Access Compliance Report

Public Rights-of-Way

(Curb Ramps)

Intersection ID: 13763	Main Street: CENTRAL_AV	Cross Street: EASTWAY_DR	Location: SW
ADA ID: 28CB189DD93A	Ramp Type: Perp	Initial Pass/Fail: Fail	Overall Compliance: No
Severity Score: 8.75			
Codes/Mitigation Info/Possible Solution		Field Measurements/Component Compliance

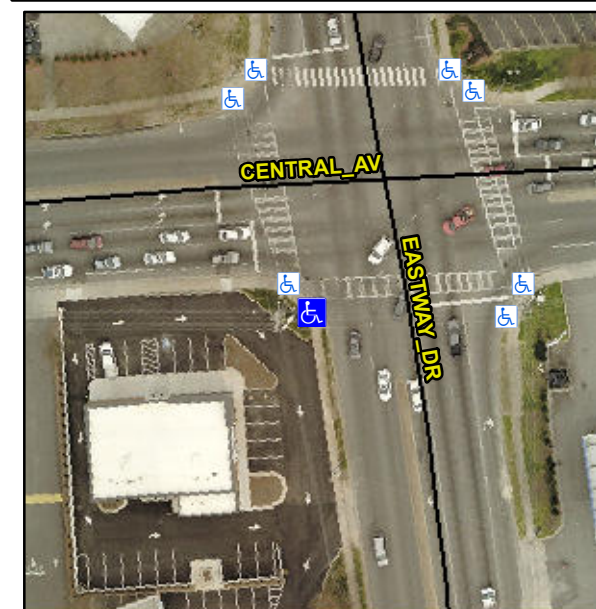
Not Found, R304.5.1

Compliance	Description	Data	Compliance	Description	Data
N/A	Ramp Length (in)	80.0	Yes	Ramp Slope (%)	5.9
No	Ramp Width (in)	45.0	Yes	Ramp XSlope (%)	1.6
N/A	Flare Type LT	N/A	N/A	Flare Type RT	N/A
N/A	Flare Slope LT (%)	N/A	N/A	Flare Slope RT (%)	N/A
N/A	Flare Traversable LT?	N/A	N/A	Flare Traversable RT?	N/A
N/A	Landing Length (in)	N/A	N/A	DWS Provided?	N/A
N/A	Landing Width (in)	N/A	N/A	DWS Contrast?	N/A
N/A	Landing Slope (%)	N/A	N/A	DWS Length (in)	N/A
N/A	Landing X Slope (%)	N/A	N/A	DWS Full Width?	N/A
N/A	Landing Curb? (Y/N)	N/A	N/A	DWS Offset (in)	N/A
N/A	Shared Landing?	N/A			
N/A	Gutter Ponding?	N/A	N/A	Gutter Slope (%)	N/A
N/A	Gutter Lip Ht (in)	N/A	N/A	Gutter X Slope (%)	N/A
N/A	Painted X Walk1?	No	N/A	Painted X Walk2?	N/A
	X Walk 1 Direction	To E		X Walk 2 Direction	N/A
N/A	X Walk 1 Width (in)	N/A	N/A	X Walk 2 Width (in)	N/A
	X Walk 1 Slope (%)	4.0		X Walk 2 Slope (%)	N/A
	X Walk 1 X Slope (%)	3.0		X Walk 2 X Slope (%)	N/A

Remove & Replace Entire Ramp.
